CA MUTCD 2026 Figure Markups (Draft)

This "Figure Comparisons" document has been prepared by Caltrans to share the changes that are reflected in CA MUTCD 2026 initial draft version figures, when compared to National MUTCD 2023 figures, as well as current CA MUTCD 2014 Revision 8 figures (which were based on National MUTCD 2009). This document identifies California specific figures that are incorporated into CA MUTCD 2026 initial draft version and figures that are not incorporated and provides brief explanation, if they aren't incorporated. This document is being provided for ease in comparison, when reviewing CA MUTCD 2026 initial draft.

Figure 7B-2. Example of Signing for a School Zone with a School Speed Limit and a School Crossing

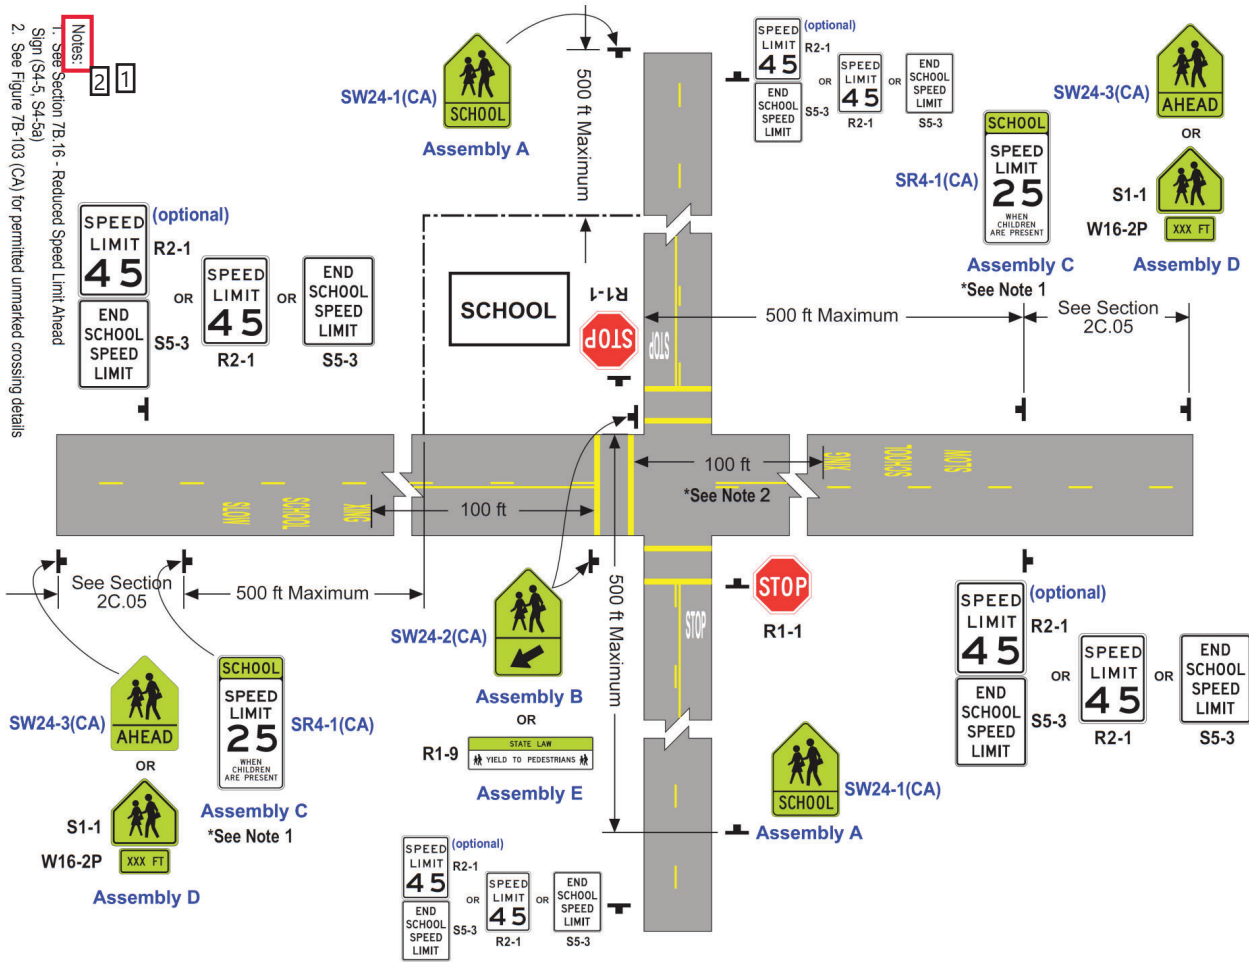
<input checked="" type="checkbox"/>	Number: 1	Author: s116730	Subject: Highlight	Date: 7/25/2024 9:48:20 AM
NMUTCD 2023 added sign codes for all signs, which were missing in NMUTCD 2009 figures				
<input checked="" type="checkbox"/>	Number: 2	Author: s116730	Subject: Highlight	Date: 7/25/2024 9:48:24 AM
NMUTCD 2023 changed NMUTCD 2009 Figure 7B-5 to 7B-2 and added sign codes for the signs shown in the figure.				
<input type="checkbox"/>	Number: 3	Author: s116730	Subject: Rectangle	Date: 7/10/2024 9:45:30 AM
Incorporated from CA MUTCD 2014R8 Figure 7B-5				
<input type="checkbox"/>	Number: 4	Author: s116730	Subject: Text Box	Date: 7/10/2024 9:43:42 AM
OR				
<input checked="" type="checkbox"/>	Number: 5	Author: s116730	Subject: Line	Date: 7/10/2024 9:37:58 AM
<input type="checkbox"/>	Number: 6	Author: s116730	Subject: Rectangle	Date: 7/10/2024 9:55:06 AM
Incorporated from CA MUTCD 2014R8 Figure 7B-5

<input type="checkbox"/>	Number: 7	Author: s116730	Subject: Rectangle	Date: 7/14/2024 8:38:40 AM
NMUTCD 2023 added new sign				
<input checked="" type="checkbox"/>	Number: 8	Author: s116730	Subject: Line	Date: 7/10/2024 9:37:47 AM
<input checked="" type="checkbox"/>	Number: 9	Author: s116730	Subject: Line	Date: 7/10/2024 9:38:20 AM
<input checked="" type="checkbox"/>	Number: 10	Author: s116730	Subject: Line	Date: 7/10/2024 9:38:20 AM
<input type="checkbox"/>	Number: 11	Author: s116730	Subject: Rectangle	Date: 7/10/2024 9:55:55 AM
Incorporated from CA MUTCD 2014R8 Figure 7B-5				
<input type="checkbox"/>	Number: 12	Author: s116730	Subject: Rectangle	Date: 7/14/2024 8:40:44 AM
NMUTCD 2023 added new cardinal direction "N" arrow				
<input type="checkbox"/>	Number: 13	Author: s116730	Subject: Rectangle	Date: 7/13/2024 10:10:07 AM
NMUTCD 2023 added new plaques				
<input type="checkbox"/>	Number: 14	Author: s116730	Subject: Rectangle	Date: 7/10/2024 2:53:25 PM

Incorporated from CA MUTCD 2014R8 Figure 7B-5				
<input type="checkbox"/>	Number: 15	Author: s116730	Subject: Rectangle	Date: 7/10/2024 2:34:53 PM
Incorporated from CA MUTCD 2014R8 Figure 7B-5				
<input type="checkbox"/>	Number: 16	Author: s116730	Subject: Rectangle	Date: 7/10/2024 2:35:20 PM
Incorporated from CA MUTCD 2014R8 Figure 7B-5				
<input type="checkbox"/>	Number: 17	Author: s116730	Subject: Rectangle	Date: 7/10/2024 9:56:34 AM
Incorporated from CA MUTCD 2014R8 Figure 7B-5				
<input type="checkbox"/>	Number: 18	Author: s116730	Subject: Rectangle	Date: 7/13/2024 10:10:21 AM
NMUTCD 2023 added new plaques				
<input checked="" type="checkbox"/>	Number: 19	Author: s116730	Subject: Line	Date: 7/10/2024 9:51:04 AM
<input checked="" type="checkbox"/>	Number: 20	Author: s116730	Subject: Line	Date: 7/10/2024 9:50:49 AM
<input checked="" type="checkbox"/>	Number: 21	Author: s116730	Subject: Line	Date: 7/10/2024 9:40:05 AM

<input checked="" type="checkbox"/>	Number: 22	Author: s116730	Subject: Line	Date: 7/10/2024 9:39:53 AM
<input type="checkbox"/>	Number: 23	Author: s116730	Subject: Rectangle	Date: 7/10/2024 9:56:16 AM
Incorporated from CA MUTCD 2014R8 Figure 7B-5				
<input type="checkbox"/>	Number: 24	Author: s116730	Subject: Rectangle	Date: 7/10/2024 9:57:20 AM

Number: 25 Author: s116730 Subject: Rectangle Date: 7/13/2024 10:10:35 AM
NMUTCD 2023 added new sign

Number: 26 Author: s116730 Subject: Rectangle Date: 7/10/2024 9:56:45 AM
Incorporated from CA MUTCD 2014R8 Figure 7B-5

Figure 7B-2(CA) Example of Signing for a School Zone with a School Speed Limit and a School Crossing

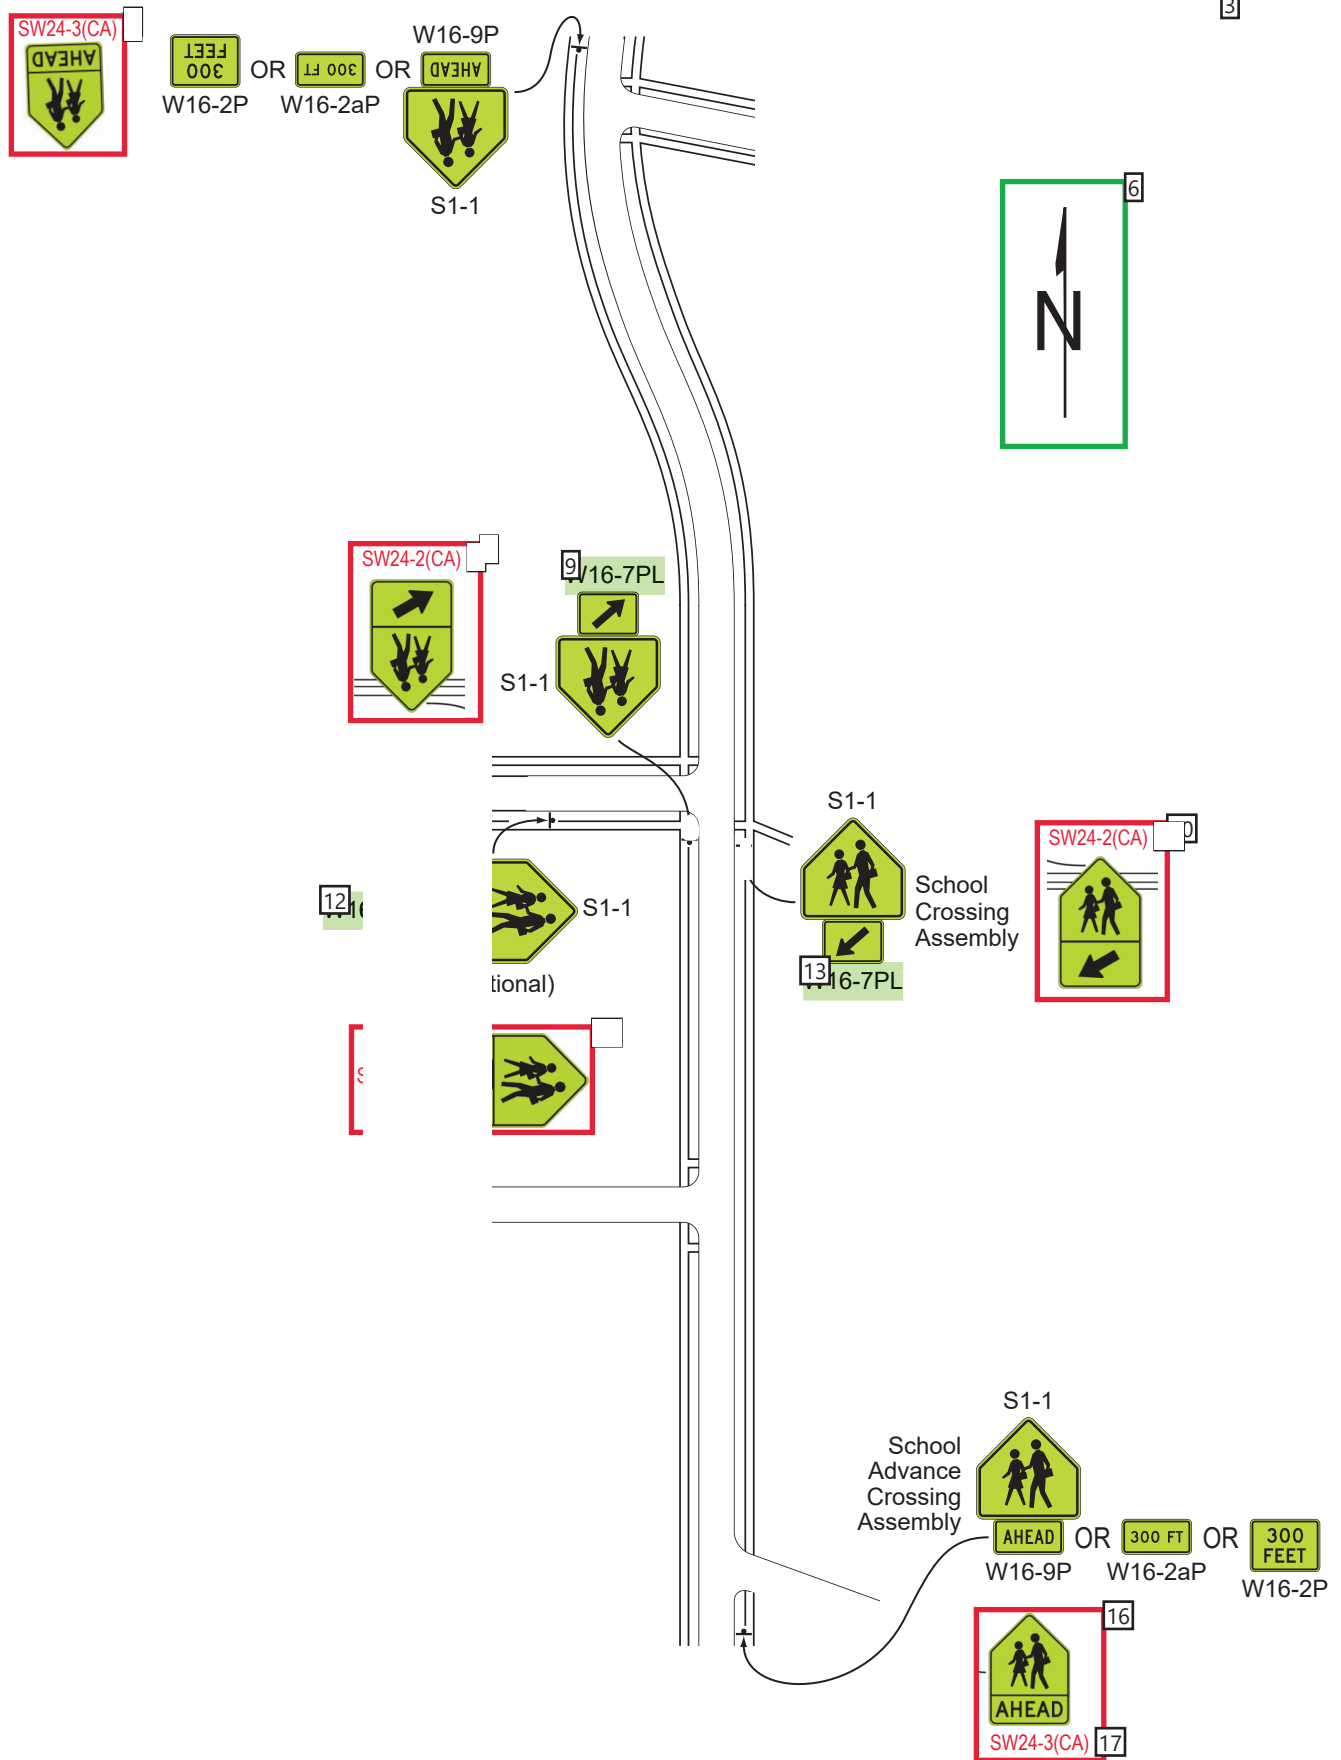
Add new note:

3. See Section 7B.02 for Assembly A(CA), Section 7B.03 for Assemblies B(CA), D(CA) and E(CA), and Section 7B.05 for Assembly C.

NMUTCD 2023 changed NMUTCD 2009 Figure 7B-5 to 7B-2. This figure is renumbered as 7B-2(CA) and is included in CA MUTCD 2026

Figure 7B-3. Example of Signing for a School Crossing Outside of a School Zone

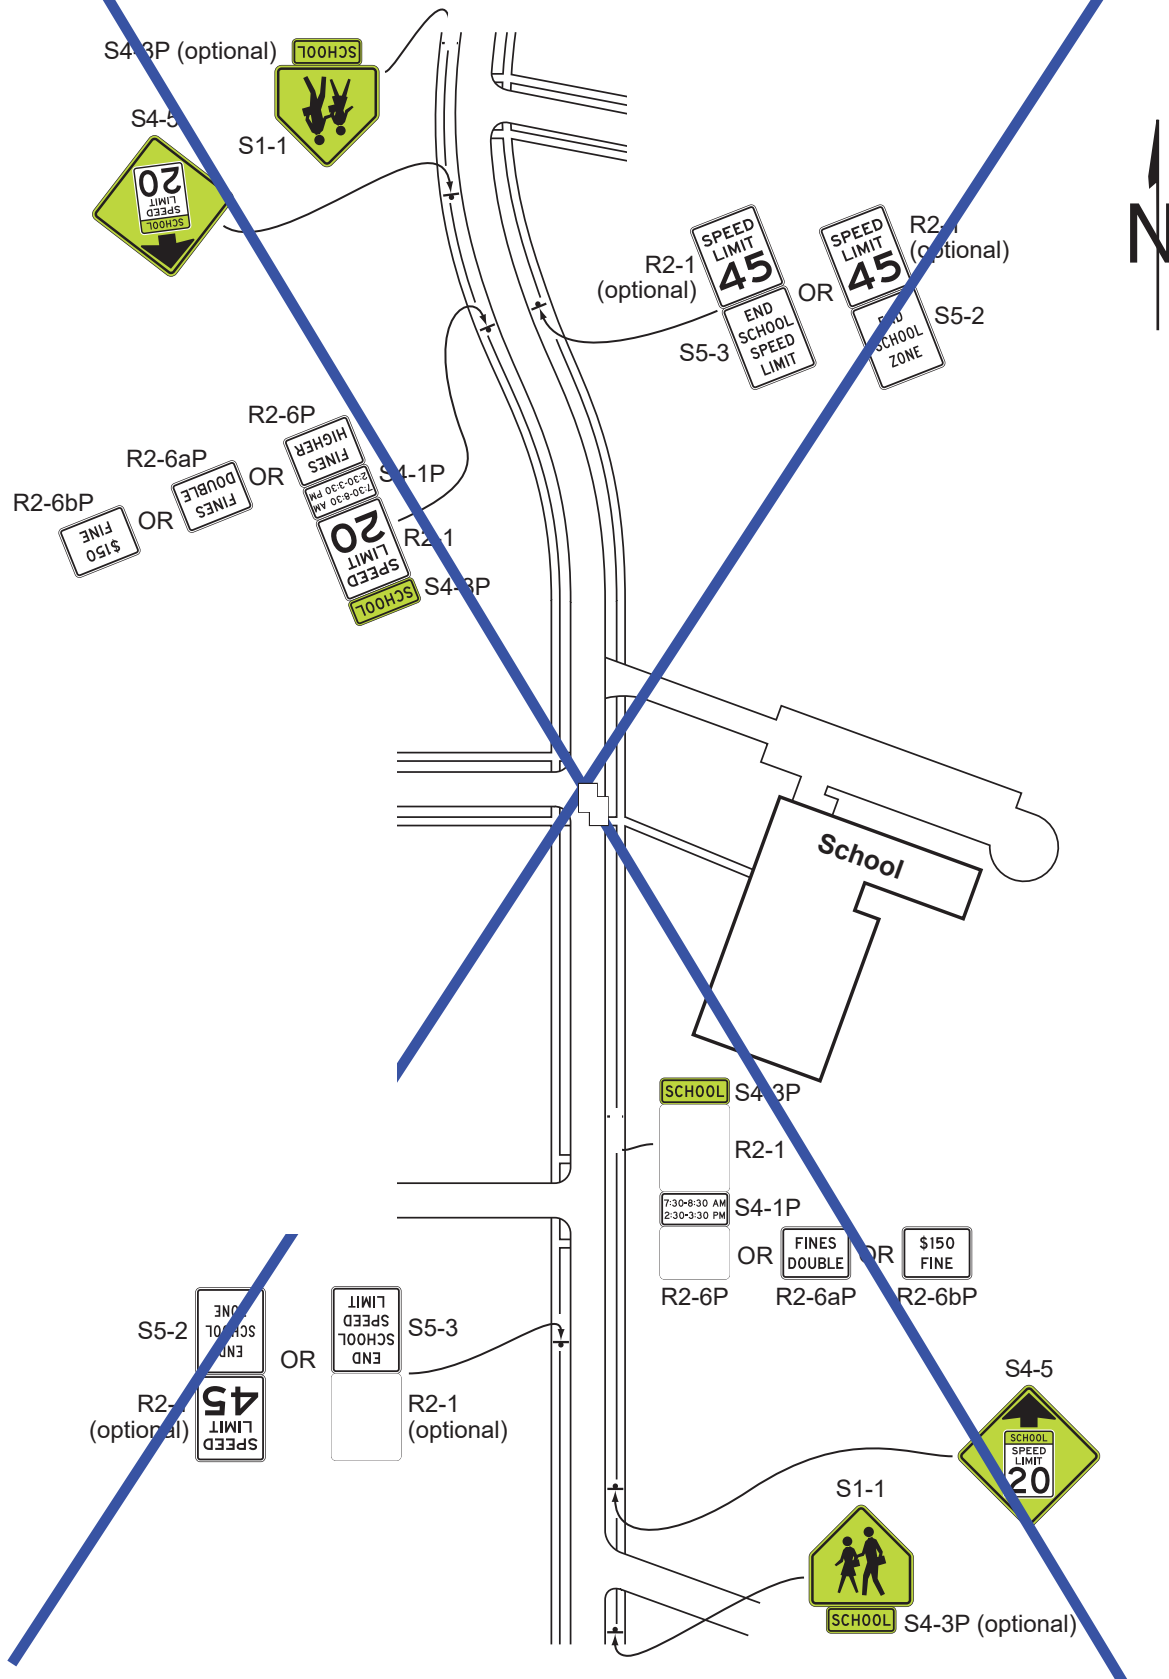
-
- Number: 1 Author: s116730 Subject: Highlight Date: 7/25/2024 9:49:29 AM
Options for CA signs that are combined with plaques (for all signs shown on this sheet) will be added

- NMUTCD 2023 added sign codes for all signs, which were missing in NMUTCD 2009 figures
-
- Number: 2 Author: s116730 Subject: Highlight Date: 7/25/2024 9:49:32 AM
NMUTCD 2023 changed NMUTCD 2009 Figure 7B-4 to 7B-3 and added sign codes for the signs shown in the figure.
-

- Number: 3 Author: s116730 Subject: Text Box Date: 7/10/2024 3:11:55 PM
-
- Number: 4 Author: s116730 Subject: Rectangle Date: 7/10/2024 3:20:12 PM
Add SW24-3(CA) Assembly D(CA) image
-

- Number: 5 Author: s116730 Subject: Text Box Date: 7/10/2024 2:56:21 PM
SW24-3(CA)
-
- Number: 6 Author: s116730 Subject: Rectangle Date: 7/14/2024 8:41:23 AM
NMUTCD 2023 added new cardinal direction "N" arrow
-

- Number: 7 Author: s116730 Subject: Rectangle Date: 7/10/2024 3:21:59 PM
Add SW24-2(CA) Assembly B(CA) image
-
- Number: 8 Author: s116730 Subject: Text Box Date: 7/10/2024 2:59:39 PM
SW24-2(CA)
-

- Number: 9 Author: s116730 Subject: Highlight Date: 7/25/2024 9:49:59 AM
NMUTCD 2023 changed the NMUTCD 2009 sign code "W16-7P" to "W16-7PL"
-
- Number: 10 Author: s116730 Subject: Rectangle Date: 7/10/2024 3:21:47 PM
Add SW24-2(CA) Assembly B(CA) image
-

- Number: 11 Author: s116730 Subject: Text Box Date: 7/10/2024 3:00:31 PM
SW24-2(CA)
-
- Number: 12 Author: s116730 Subject: Highlight Date: 7/25/2024 9:50:05 AM
NMUTCD 2023 changed the NMUTCD 2009 sign code "W16-6P" to "W16-6PR"
-

- Number: 13 Author: s116730 Subject: Highlight Date: 7/25/2024 9:50:09 AM
NMUTCD 2023 changed the NMUTCD 2009 sign code "W16-7P" to "W16-7PL"
-
- Number: 14 Author: s116730 Subject: Rectangle Date: 7/10/2024 3:23:06 PM
Add SW24-1(CA) Assembly A(CA) image
-

- Number: 15 Author: s116730 Subject: Text Box Date: 7/10/2024 3:05:01 PM
SW24-1(CA)
-
- Number: 16 Author: s116730 Subject: Rectangle Date: 7/10/2024 3:22:25 PM
Add SW24-3(CA) Assembly D(CA) image
-

Figure 7B-4. Example of Signing for a School Zone with a School Speed Limit and Higher Fines Only for Speeding

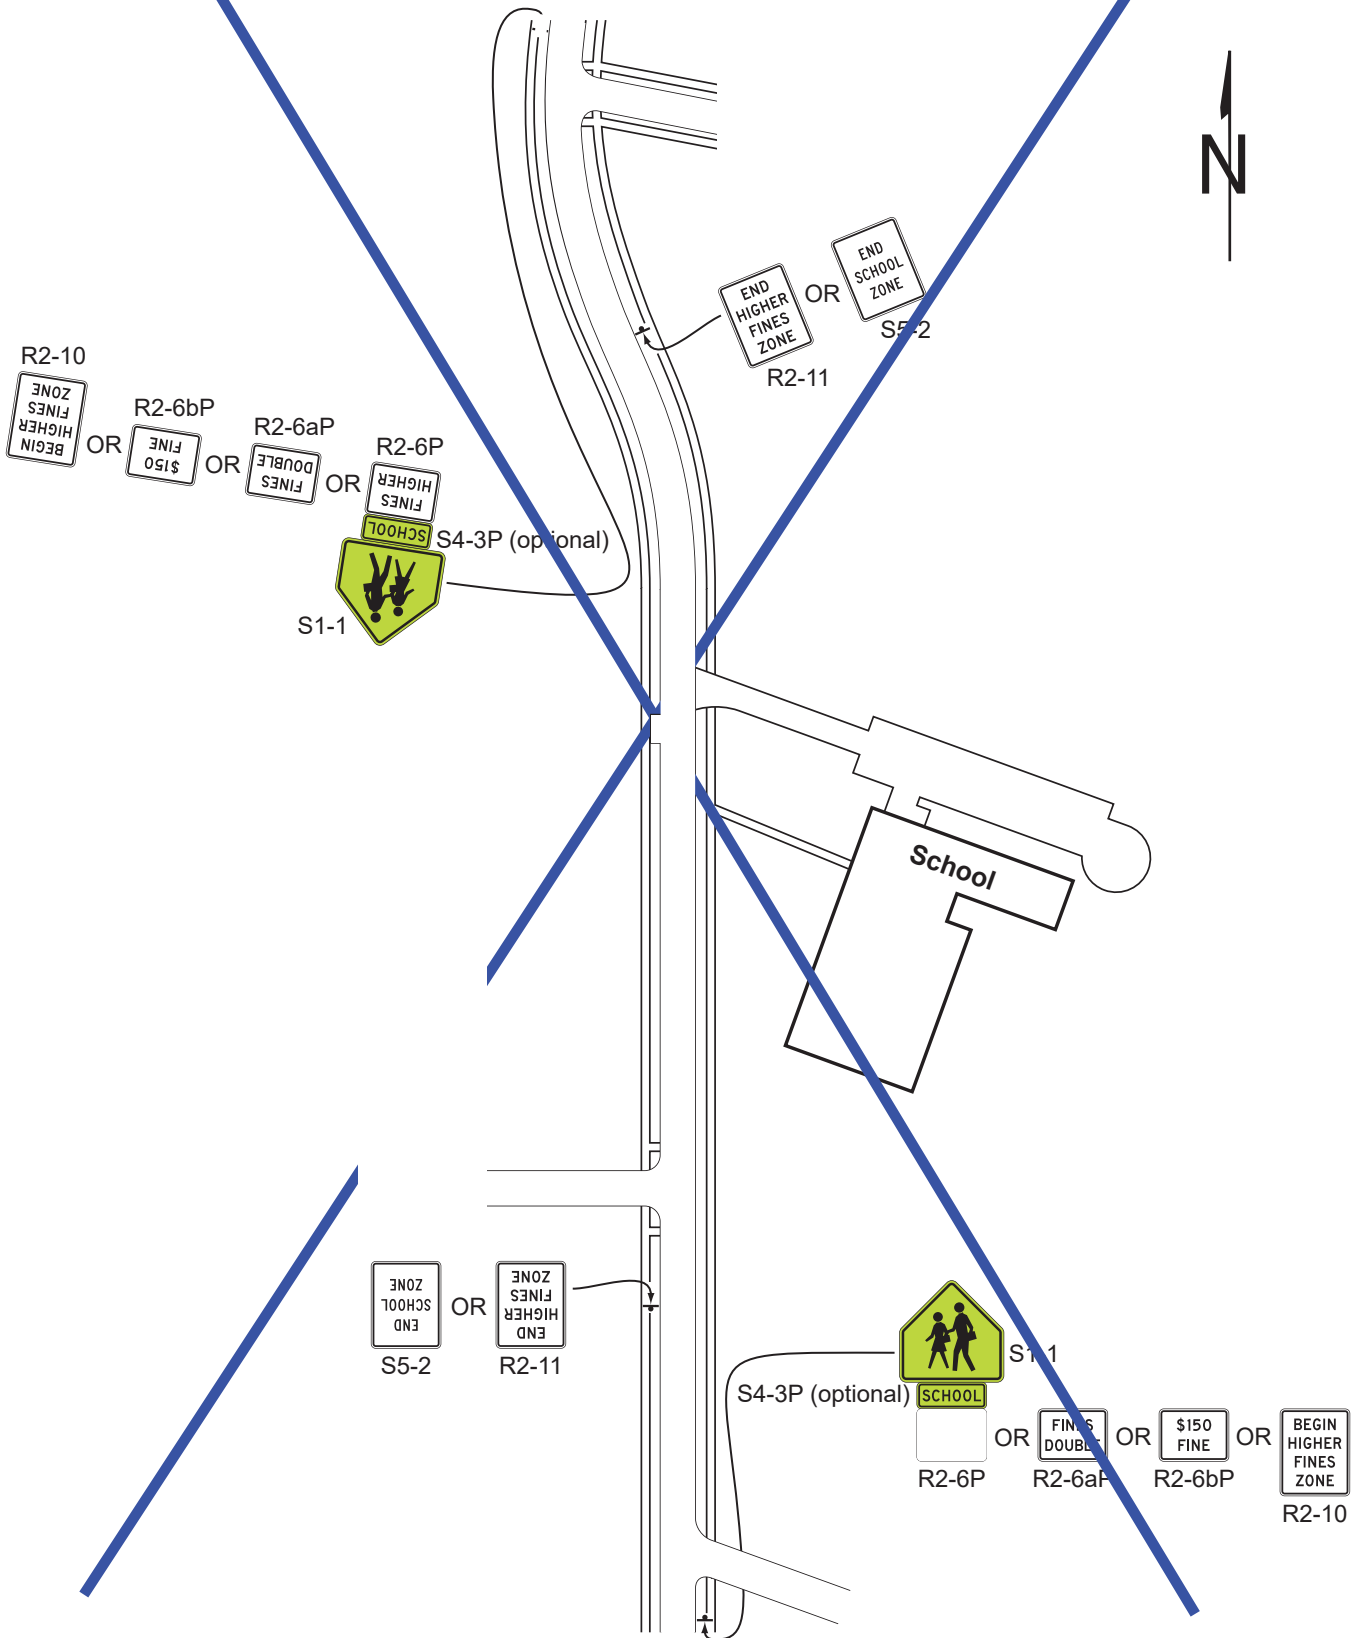
Number: 3 Author: s116730 Subject: Highlight Date: 7/25/2024 9:50:21 AM
NMUTCD 2023 changed NMUTCD 2009 Figure number 7B-3 to 7B-4 and made other minor changes in the figure. This figure was shown in CA MUTCD 2014R8 with a blue "X".NMUTCD 2023 Figure 7B-4 is shown in CA MUTCD 2026 with a blue "X"

Since this figure is not applicable in CA, specific changes made in NMUTCD 2023 have not been identified.
